Orano Canada Inc., Cluff Lake Project

Request to Revoke the Current Licence and
Release the Cluff Lake Project to the
Institutional Control Program

Revocation of Cluff Lake Uranium Mine Lease

ACFN Concerns and Recommendations Prepared for
the CNSC Public Hearing on March 1, 2023

Vegetation

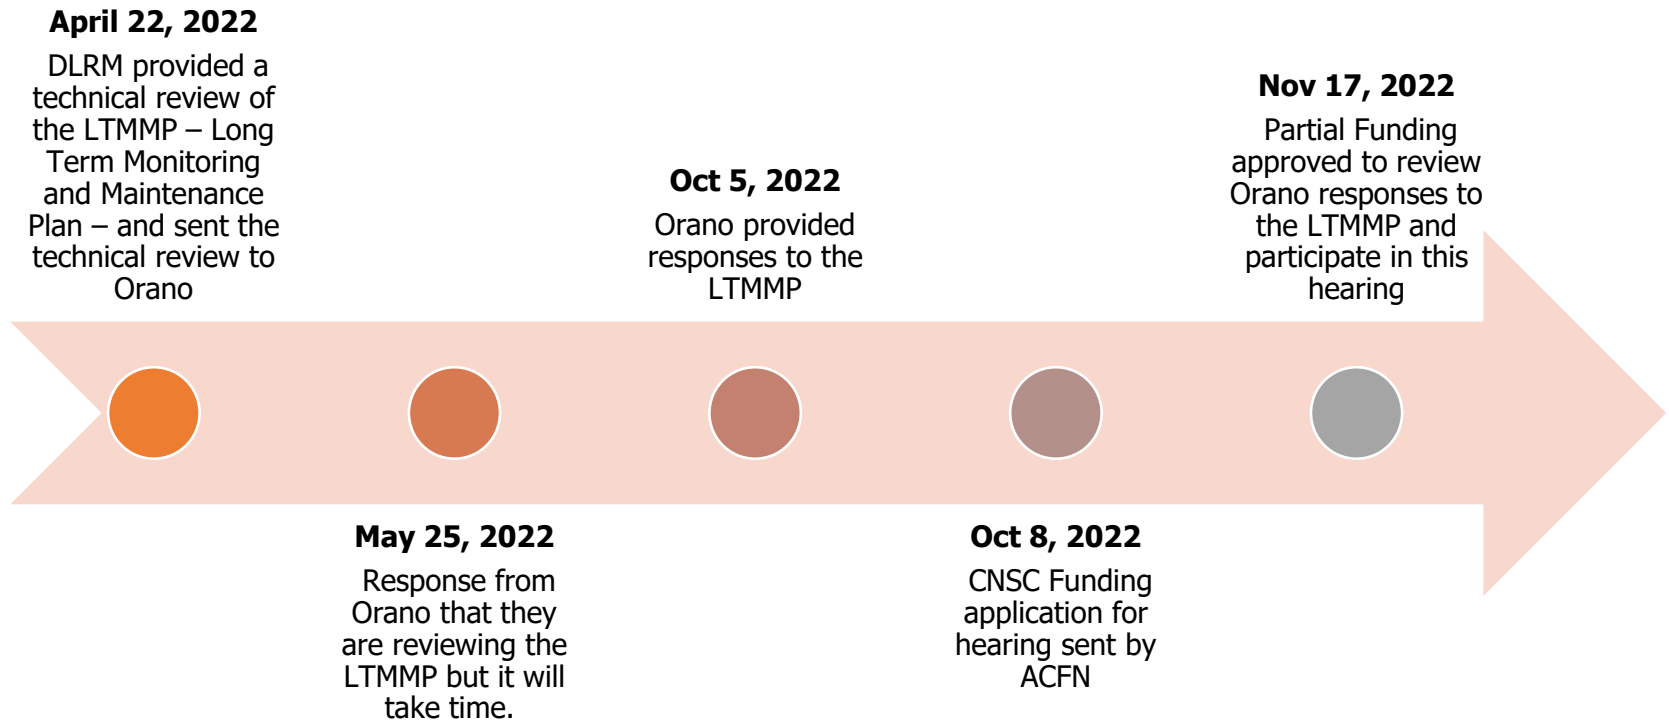
- Low lying vegetation and grasses instead of a rich boreal forest
- Orano has stated its main objective has been to restore the land to: “similar in appearance and land capability as existed prior to mining activities”
